Rebuttal Statement concerning Air Quality Matters in Boydell Court, NW8 6NH. Appeal Ref: APP/X5210/W/24/3355163

Appellant's Response to the Council's Statement

Figure 3.3: 2019 LAEI modelled annual mean NO₂ concentration for 2025

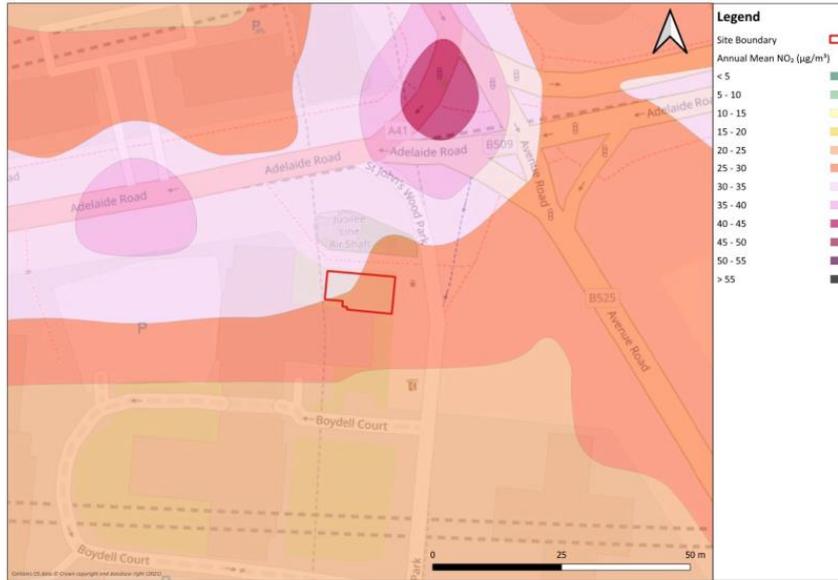
- London Atmospheric Emissions Inventory (LAEI) 2025 projections of 2019 modelling - The AQA should not use old projections to 2025 as these are based on assumptions. If 2019 mapping indicates the area has poor air quality, then as the proposal introduces new receptors, the AQA should model the site using DEFRA background concentrations/traffic data and sense check against recent monitoring data. **Response: Following the London Borough of Camden Air Quality Planning Guidance Table 1: Air quality assessment triggers using LAEI 2019 modelled concentrations for 2025 and LBC monitoring data at worse case locations than the proposed development site, it is indicated that neither Basic or Detailed air quality assessment is required. Basic assessment was provided at LBC's request and shows the criteria for either Basic or Detailed air quality assessment is not met as the site and worse case monitoring locations are not within 5% of the AQO and there are no impacts from the proposed development. It is, therefore, both illogical and unreasonable that a Detailed assessment is required when LBC's own guidance says that and air quality assessment is Not required.**

Considering the most recent mapping of the site from the LAEI 2019 (see below) the site is considered to be in an area of particularly poor air quality and therefore it was expected that the AQA having noted this would have undertaken up to date site specific modelling in order to determine the current air quality for the site and appropriate use of the site or mitigation required such as design considerations including setting residential property back from polluted roads and other sources.

Response: The concentrations in the LAEI2019 for 2019 are for concentrations over 5 years prior to when the proposed development would be occupied and do not include the reduction in concentrations from the ULEZ, other GLA measures and measures in the LBC Air Quality Action Plan. The effect of these measures is clearly shown through the measured concentrations in the LBC Air Quality Annual Status Reports. The development itself does not generate traffic and so has no impacts that require modelling. The measured concentrations at worse case locations closer to busier roads show air quality assessment is not required, following LBC's air quality planning guidance. To not consider their own guidance and improvements in air quality from 2019 to 2025 appears to be an illogical, irrational and questionable approach to making planning decisions.
